**FLORIDA POWER CORPORATION**  
 ST. PETERSBURG, FLORIDA  
 CRYSTAL RIVER PLANT  
 UNIT NO. 3 855,000 KW

ELECTRICAL  
 CONDUIT LAYOUT  
 INTERMEDIATE BLDG. - EL. 95' - 8"

DATE: 4-20-52  
 DRAWING NO.: E-215-046  
 SHEET NO.: 1 OF 1

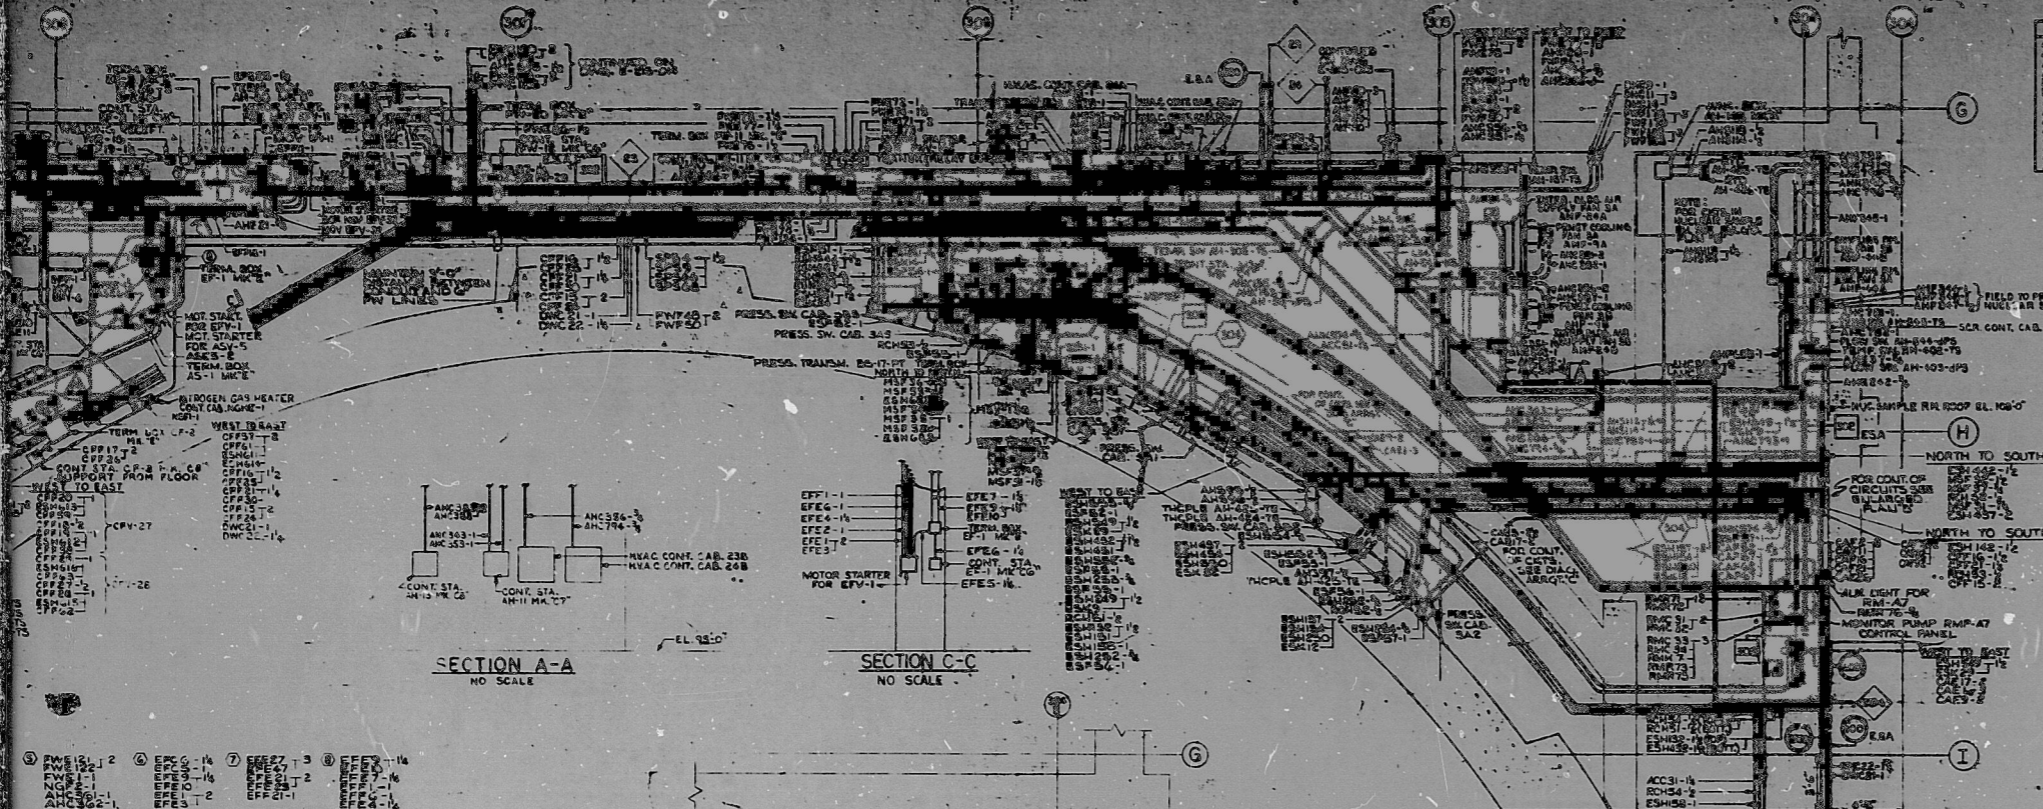
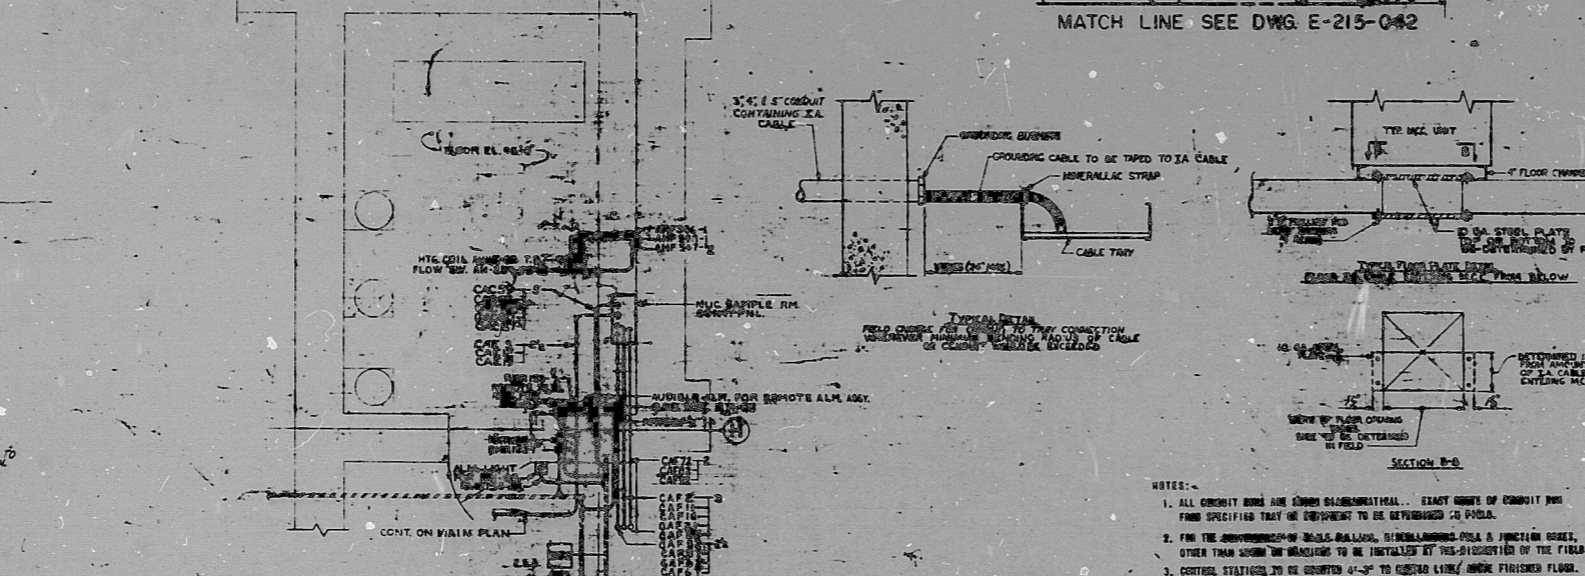
CHANGE IN PROGRESS  
 DUE TO  
 MAR./REL. 10-2-52

INSTALL FIRE SHIELD ON CONDUIT RUN. SEE DETAIL 13 DWG. E-214-061
